# AGENDA FOR THE REGULAR MEETING OF THE DESIGN REVIEW SUBCOMMITTEE

Wednesday, April 23, 2014 10:00 a.m.

SUBJECT: PRE-APP 14-106, Elena Lane 6-Unit Condos, a request to review

<u>Discretionary Sign Permit 14-066/ Minor Cultural Heritage Permit 14-067, Pep Boys Signage</u>, a request to consider a Master Sign Program and exterior modifications to an automobile service station building within the Architectural Overlay. The project is located at 1606 North El Camino Real in the Mixed-Use (MU2-p-A) zoning district and Pedestrian and

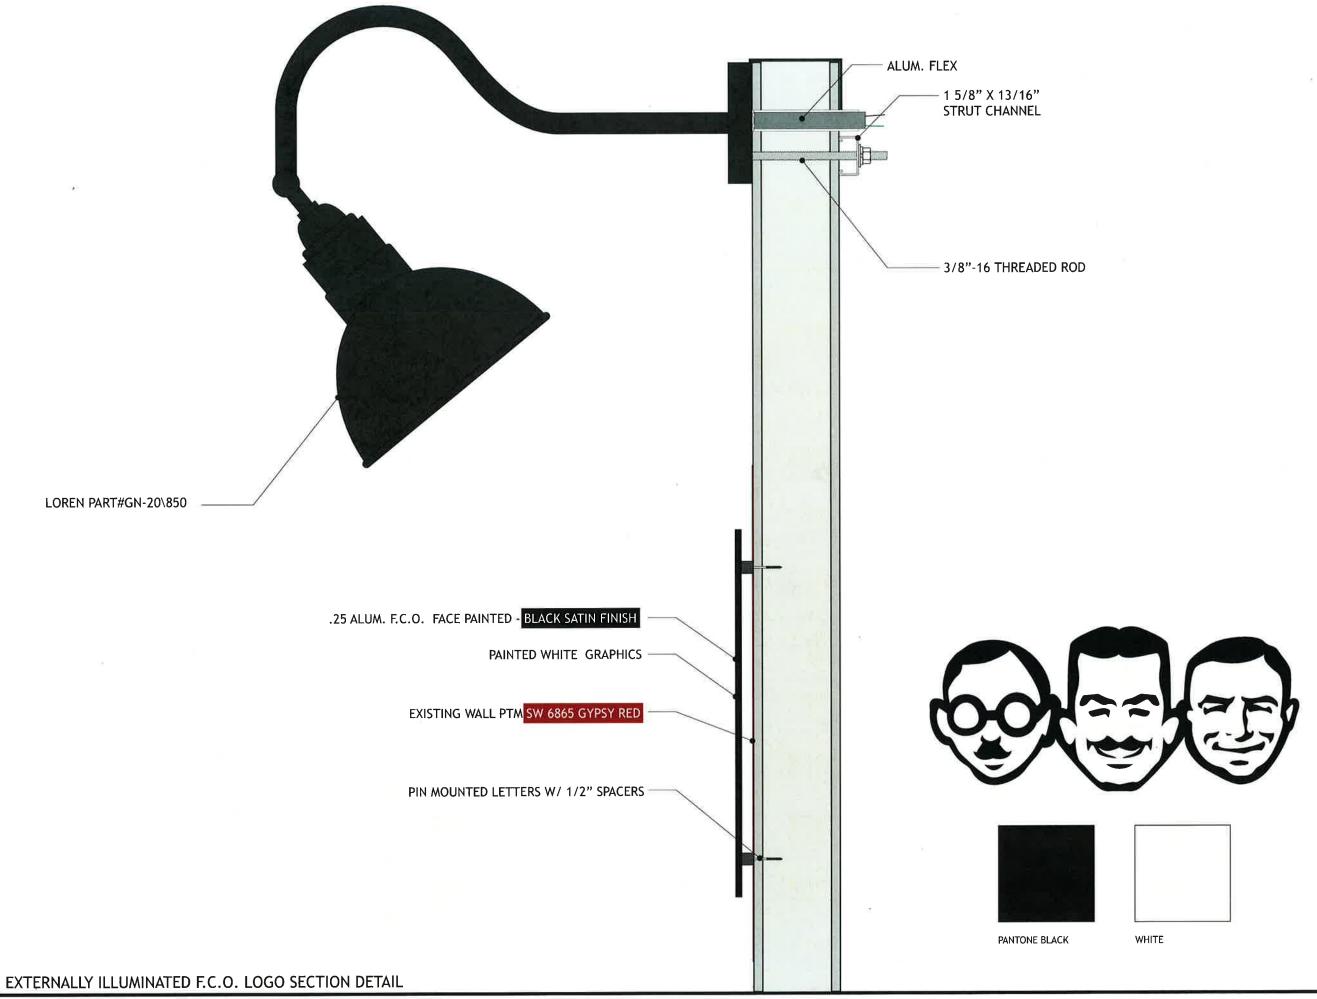
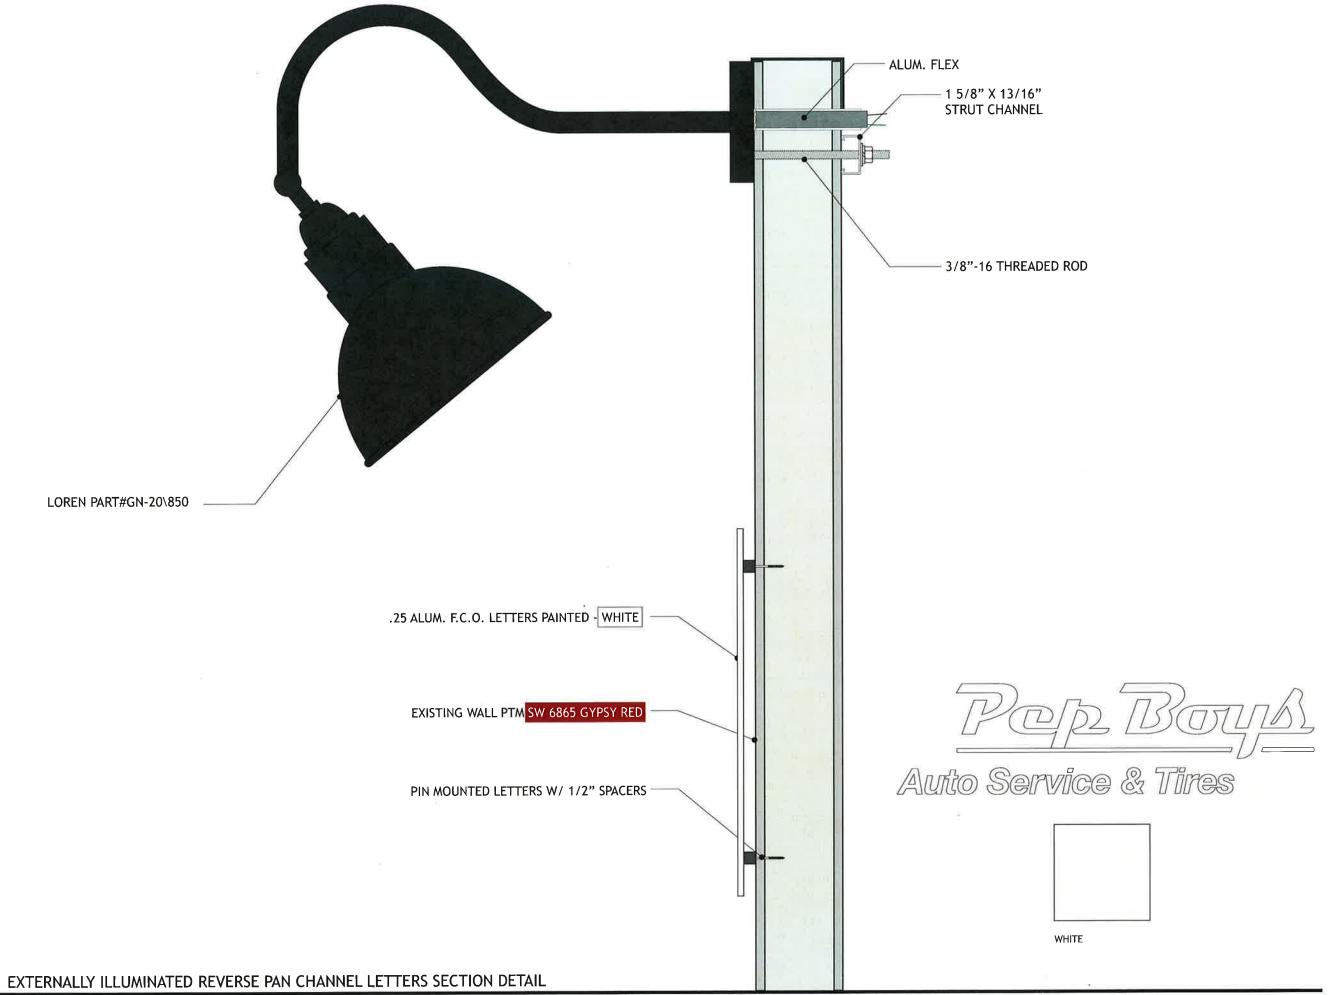
The 56 square foot sign located on the north wall is parallel to the direction of traffic and is across the street from a two-story building that blocks any long-range visibility from the northeast. The sign would also be hard to see for north-bound motorists because the view is distorted until they are nearly directly in front of it. By the time the sign comes into full view a 56 square foot sign is not necessary to attract their attention. This sign is not necessary to attract south-bound motorists, because the 27 square foot sign on the west wall is much more visible in that direction. Photos demonstrating the visibility of this sign are included as Attachment 3.

From a pedestrian perspective, a 56 square foot sign that is within a few feet of the sidewalk and 10 feet above grade is out of scale and dominates the building's façade,

Both signs include a red painted rectangle to provide contrast against the white lettering and logo. Though contrast is a necessary aspect of adequate signage, the addition of the red background is not consistent with other recent sign approvals for businesses along El Camino Real or the requirement that signage in the Architectural Overlay have a hand-made appearance. An example of this can be seen at the new Ralph's grocery store located at 800 South El Camino Real. That business's corporate logo is also white letters on a red background, however the approved signage consists of a dark bronze pin-mounted logo against the white building walls. Unlike the new Ralph's, Pep Boys is located in the Architectural Overlay, and the City's Design Guidelines and General Plan are more specific about the architectural compatibility with the surrounding neighborhood.

- 1. Staff recommends the sign located on the north wall be no larger than 20 square feet, or be modified to a blade sign that hangs out from the building.
- 2. Staff recommends the applicant revise the signs to be black pin-mounted aluminum letters with a black pin-mounted outlined logo to maintain consistency with other approvals and to enhance the building's compatibility with the surrounding properties and the entire NB/NECR Focus Area.
- 3. Staff recommends the walls remain white to increase compatibility with the North Beach district, and to increase contrast against the recommended black pinmounted signs.
